Contract #: 04-0120F4Cty: SF/ALA Rte: 80 PM: 13.2/13.9File #: 69.28**WELDING INSPECTION REPORT****Resident Engineer:**Siegenthaler, Peter**Address:** 333 Burma Road**City:** Oakland, CA 94607**Report No:** WIR-025603**Date Inspected:** 16-Jul-2011**Project Name:** SAS Superstructure**OSM Arrival Time:** 700**Prime Contractor:** American Bridge/Fluor Enterprises, a JV**OSM Departure Time:** 1900**Contractor:** Zhenhua Port Machinery Company, Ltd (ZPMC), Changxing Island **Location:** Shanghai, China**CWI Name:** Lu Hua Jie**CWI Present:** Yes No**Inspected CWI report:** Yes No N/A**Rod Oven in Use:** Yes No N/A**Electrode to specification:** Yes No N/A**Weld Procedures Followed:** Yes No N/A**Qualified Welders:** Yes No N/A**Verified Joint Fit-up:** Yes No N/A**Approved Drawings:** Yes No N/A**Approved WPS:** Yes No N/A**Delayed / Cancelled:** Yes No N/A**Bridge No:** 34-0006**Component:** OBG**Summary of Items Observed:**

OBG TA YARD, SEGMENT 14W

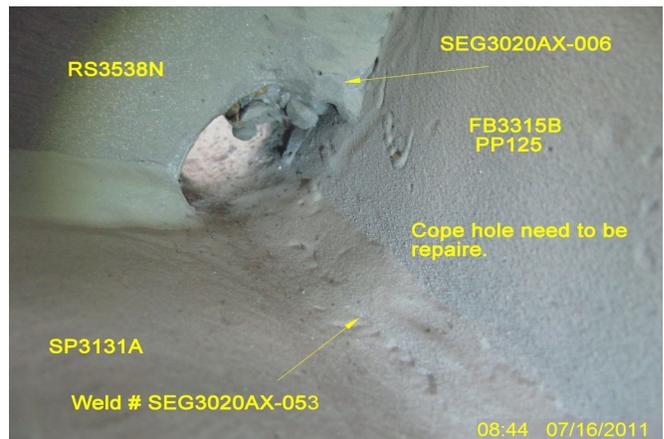
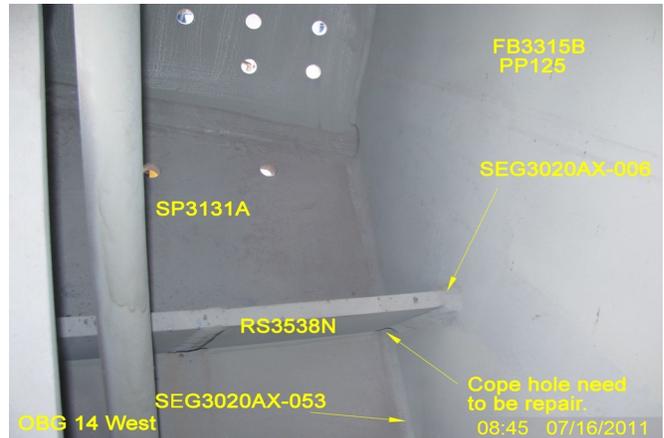
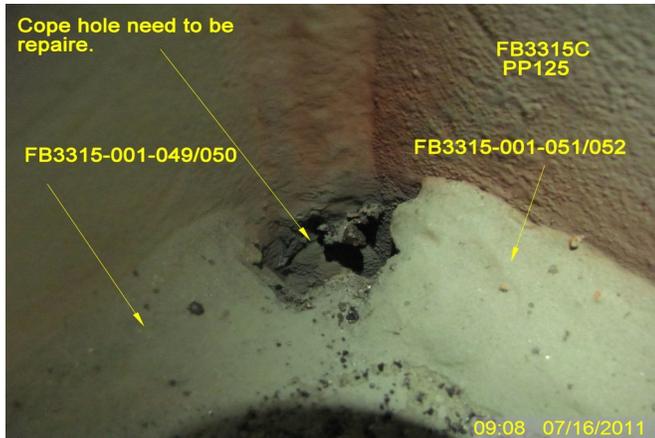
This QA Inspector performed random visual Inspection for verification of the cope holes in internal section of OBG 14 West on bike path side from panel point 125 to 126. During the verification this QA Inspector observed some cope holes are not acceptable that need to be repaired by grinding and welding. See attached photos for additional detail.
